# HISTORIC AND DESIGN REVIEW COMMISSION

February 15, 2023

**HDRC CASE NO:** 2023-038  
**ADDRESS:** 202 N ST MARYS ST  
130 N ST MARYS ST  
**LEGAL DESCRIPTION:** NCB 405 BLK LOT N 109.8 FT OF 1 & 2  
NCB 405 (SAA- OMI TRACT), LOT 10  
**ZONING:** D, HE, RIO-3  
**CITY COUNCIL DIST.:** 1  
**LANDMARK:** Individual Landmark  
**APPLICANT:** Anthony Byron  
**OWNER:** St Mary's Catholic Church  
**TYPE OF WORK:** Construction of a 17-story hotel tower  
**APPLICATION RECEIVED:** January 31, 2023  
**60-DAY REVIEW:** Not applicable due to City Council Emergency Orders  
**CASE MANAGER:** Edward Hall  
**REQUEST:**

The applicant is requesting a Certificate of Appropriateness for approval to construct a hotel tower to feature seventeen stories, not including the river level, to feature an overall height of approximately 203 feet. The proposed hotel received final approval in May 2019 but has since been amended regarding height.

17-STORY SHADOW PROFILE  
14-STORY SHADOW PROFILE

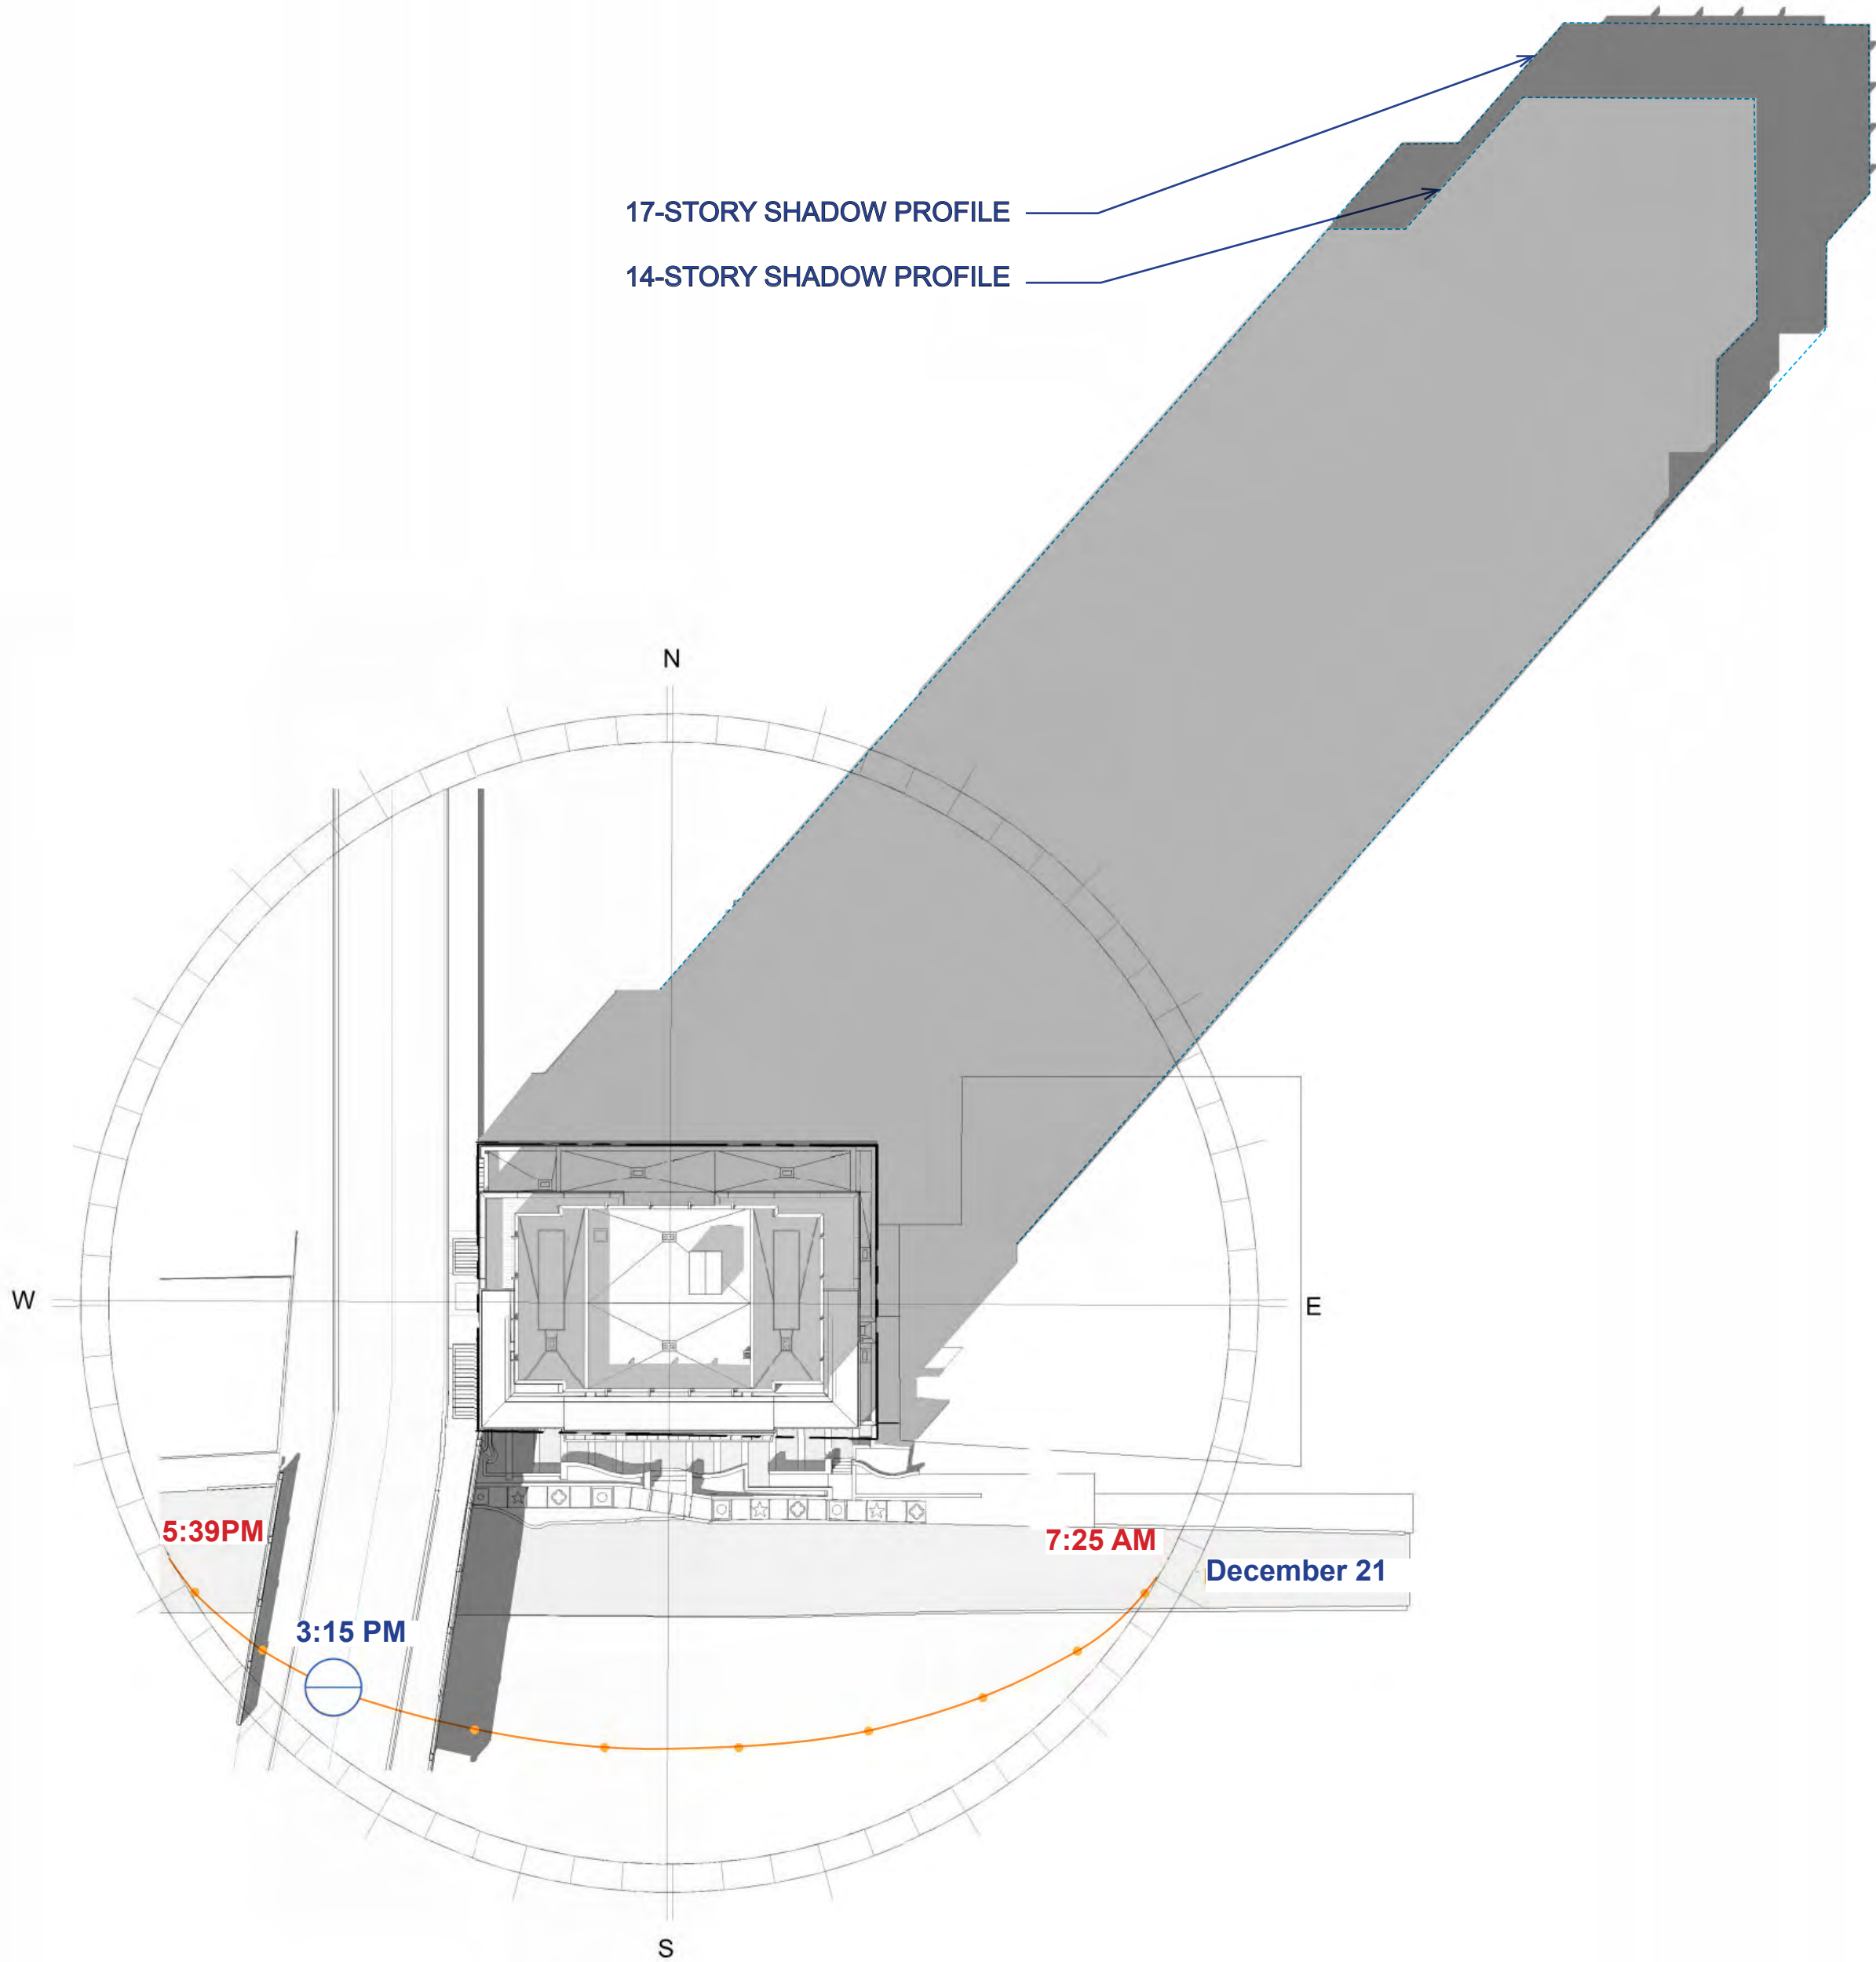
- ix. Ensure adequate solar access on the River Walk.

St Mary's Riverwalk Landscape Plan/Stone Salvage Plan

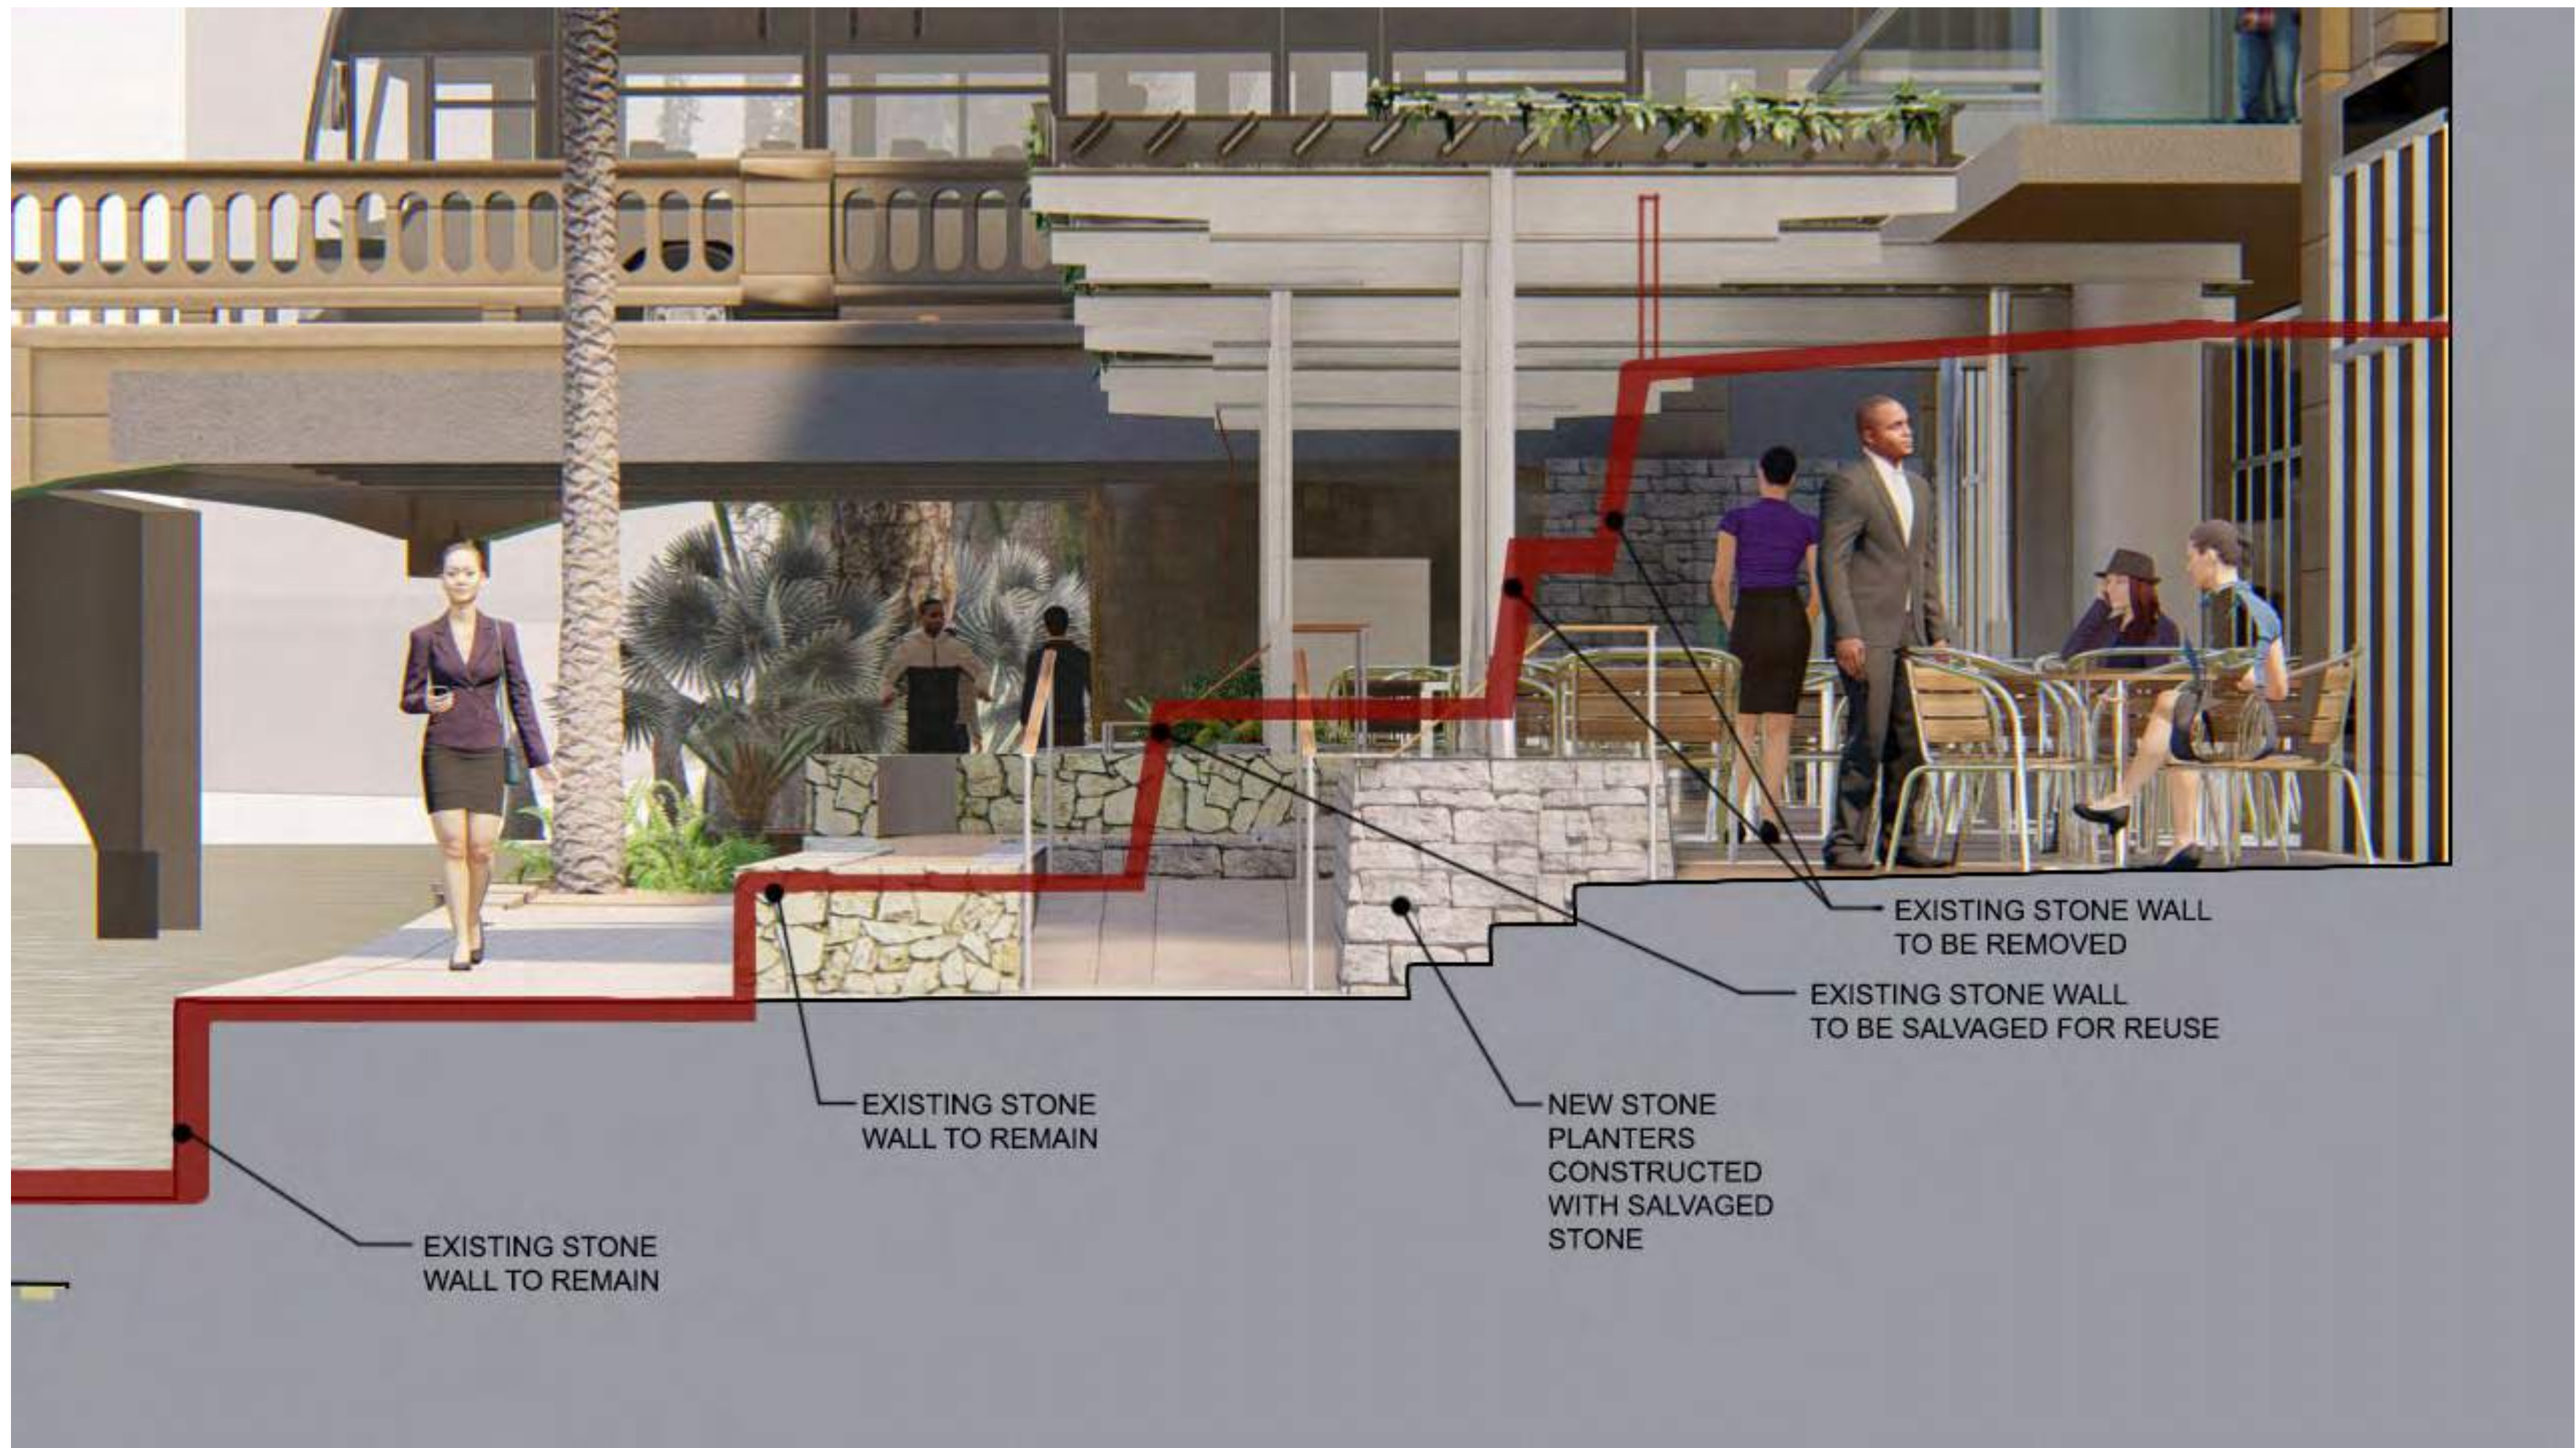
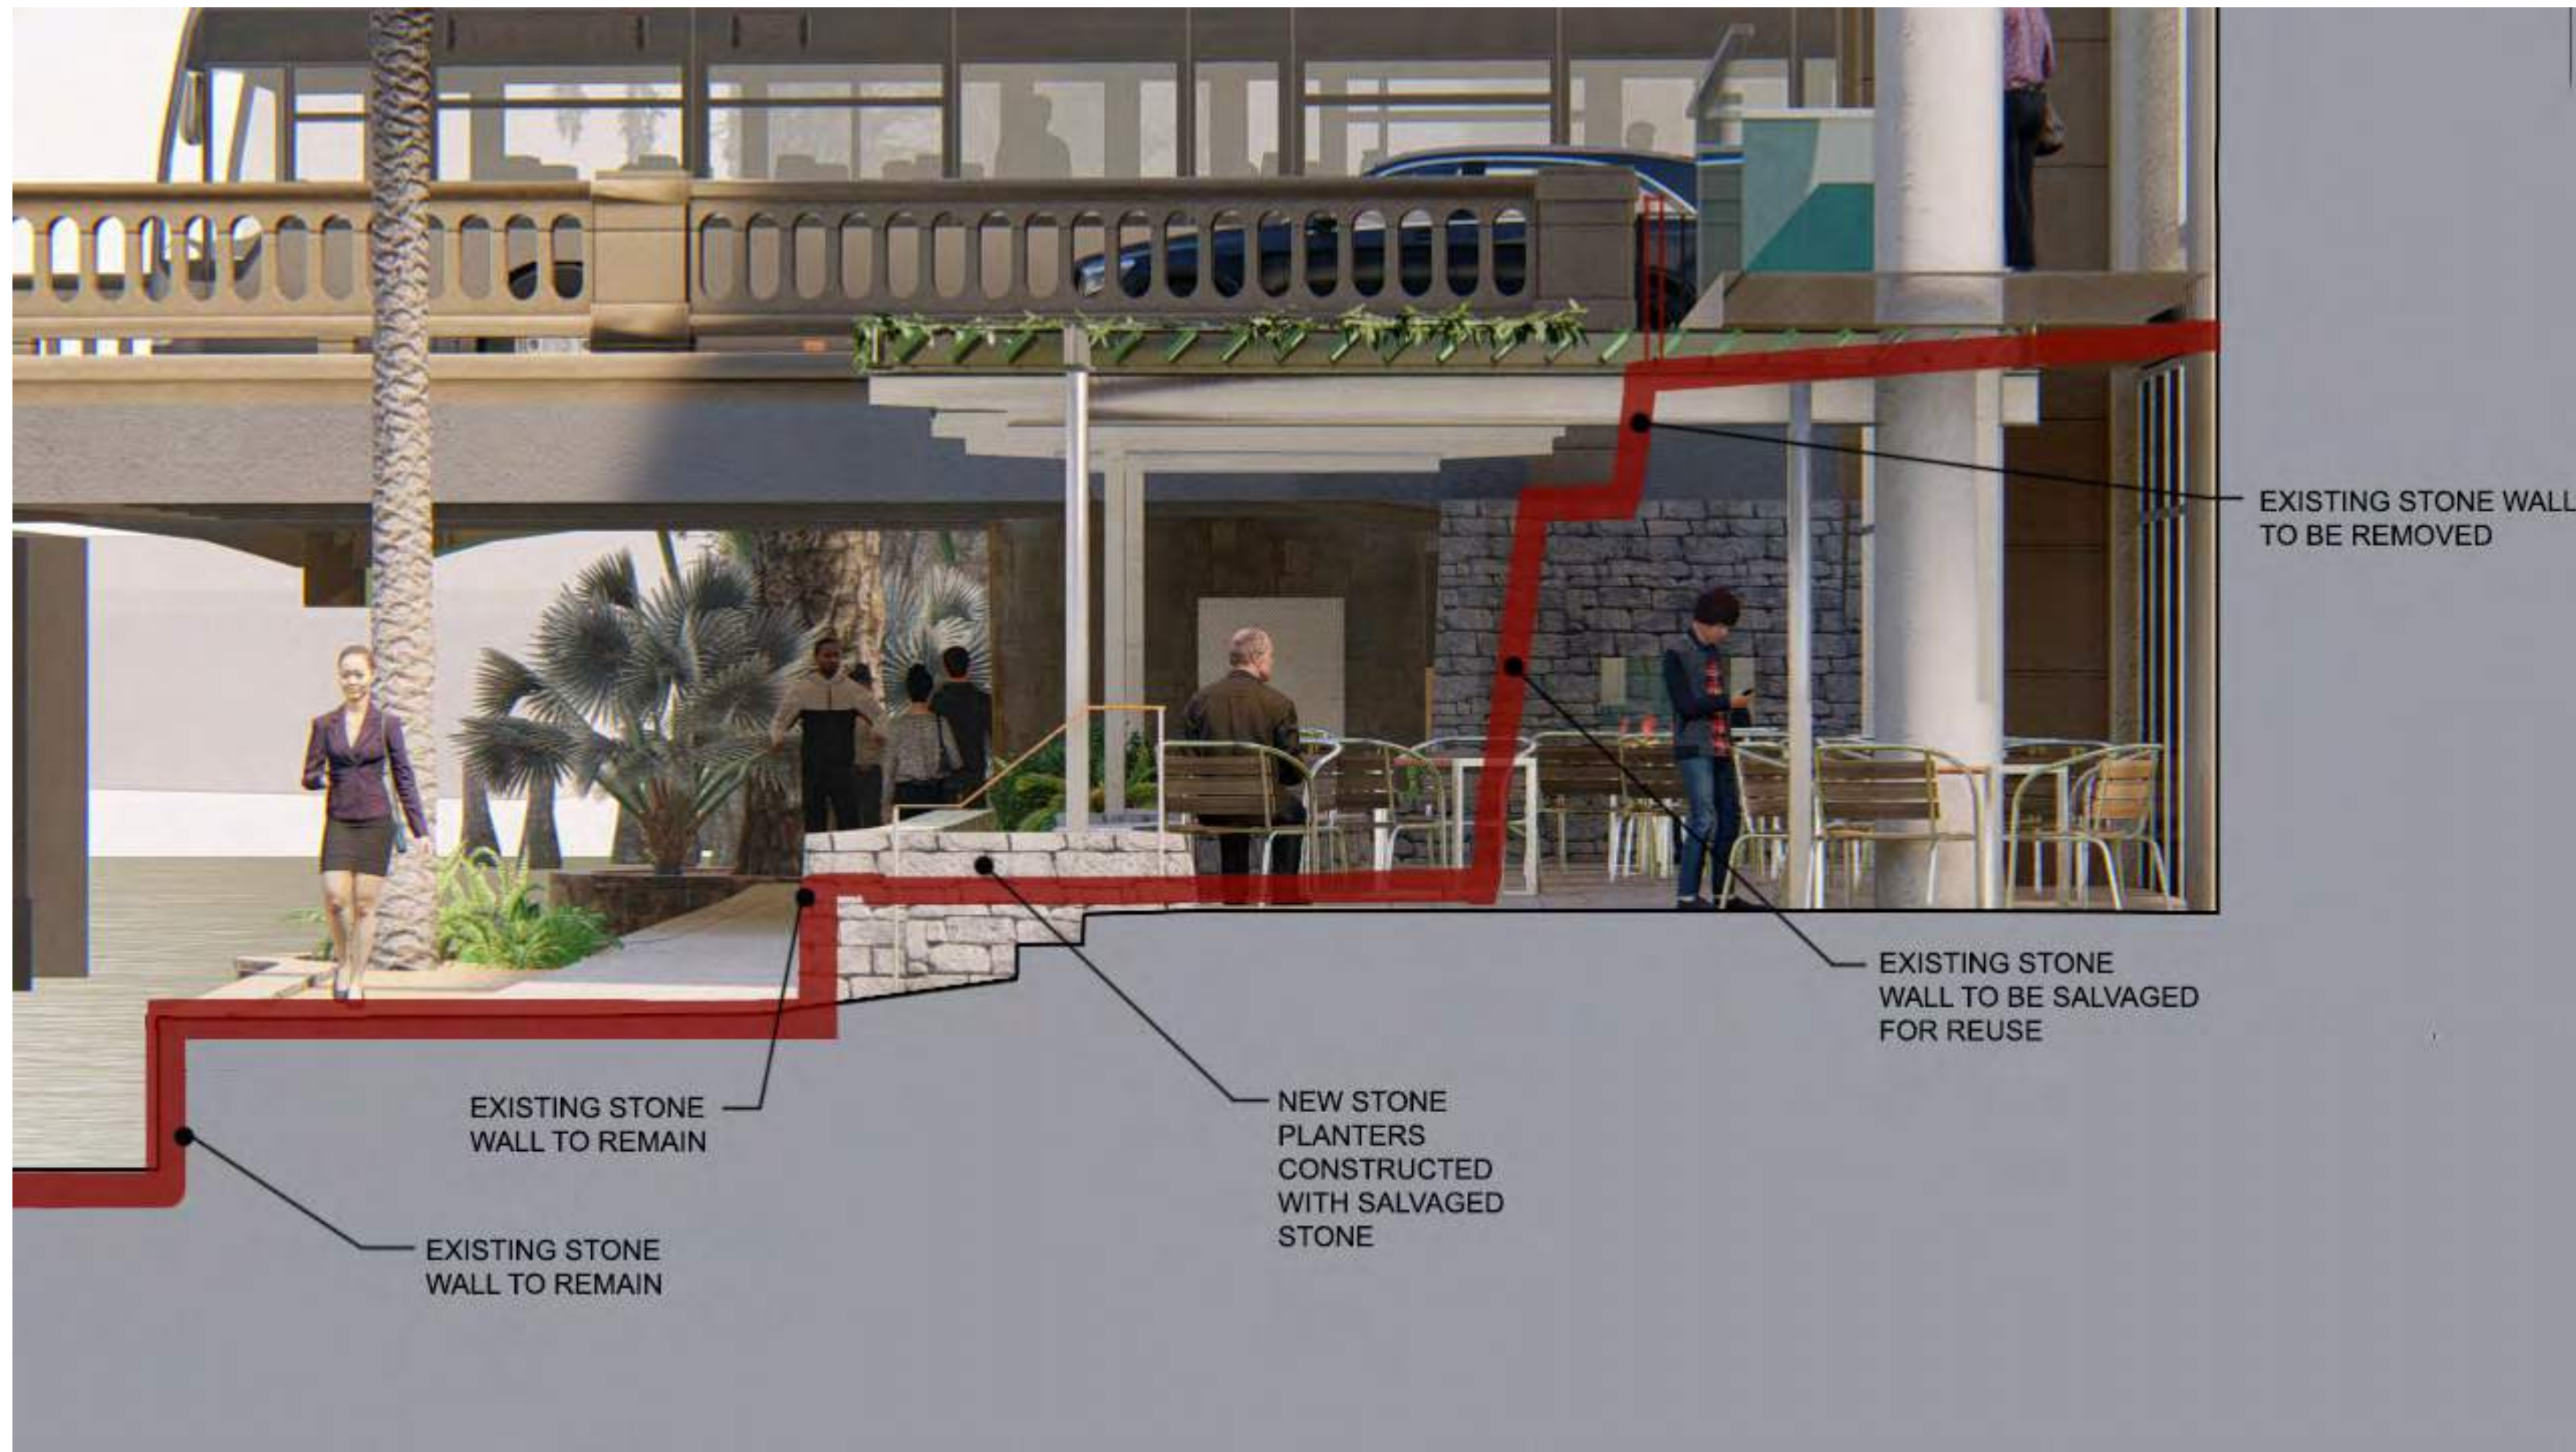
- i. That a salvage and reuse plan for existing stone elements must be provided as part of the final landscaping plan. *This stipulation has been met.*
